Access Compliance Report

Public Rights-of-Way

Intersection ID: 10033070	Main Street: NORTH_COMMUNITY_HOUSE_RD	Cross Street: N/A	Location: SW
ADA ID: C20CF7CA6D96	Ramp Type: Perp	Initial Pass/Fail: Fail	Overall Compliance: No
Severity Score: 12.5			
Codes/Mitigation Info/Possible Solution		Field Measurements/Component Compliance

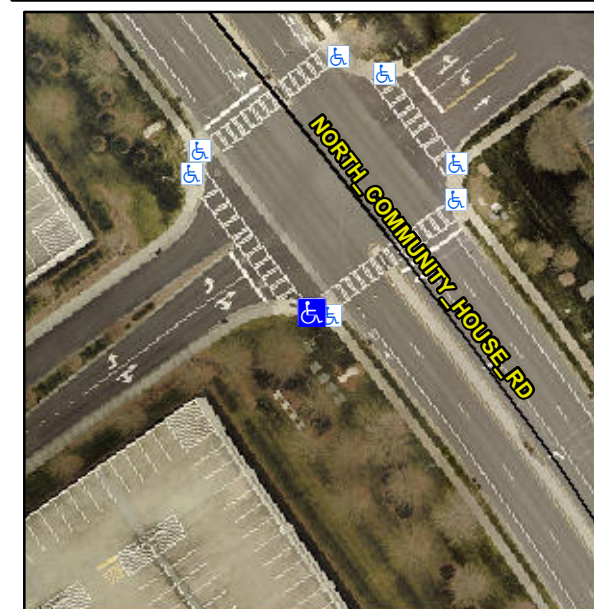
Not Found, R304.2.2

Compliance	Description	Data	Compliance	Description	Data
N/A	Ramp Length (in)	24.0	No	Ramp Slope (%)	10.0
Yes	Ramp Width (in)	48.0	Yes	Ramp XSlope (%)	1.4
N/A	Flare Type LT	N/A	N/A	Flare Type RT	N/A
N/A	Flare Slope LT (%)	N/A	N/A	Flare Slope RT (%)	N/A
N/A	Flare Traversable LT?	N/A	N/A	Flare Traversable RT?	N/A
N/A	Landing Length (in)	N/A	N/A	DWS Provided?	N/A
N/A	Landing Width (in)	N/A	N/A	DWS Contrast?	N/A
N/A	Landing Slope (%)	N/A	N/A	DWS Length (in)	N/A
N/A	Landing X Slope (%)	N/A	N/A	DWS Full Width?	N/A
N/A	Landing Curb? (Y/N)	N/A	N/A	DWS Offset (in)	N/A
N/A	Shared Landing?	N/A			
N/A	Gutter Ponding?	N/A	N/A	Gutter Slope (%)	N/A
N/A	Gutter Lip Ht (in)	N/A	N/A	Gutter X Slope (%)	N/A
N/A	Painted X Walk1?	Yes	N/A	Painted X Walk2?	N/A
	X Walk 1 Direction	To NW		X Walk 2 Direction	N/A
N/A	X Walk 1 Width (in)	112.0	N/A	X Walk 2 Width (in)	N/A
	X Walk 1 Slope (%)	0.2		X Walk 2 Slope (%)	N/A
	X Walk 1 X Slope (%)	5.5		X Walk 2 X Slope (%)	N/A

Remove & Replace Entire Ramp.
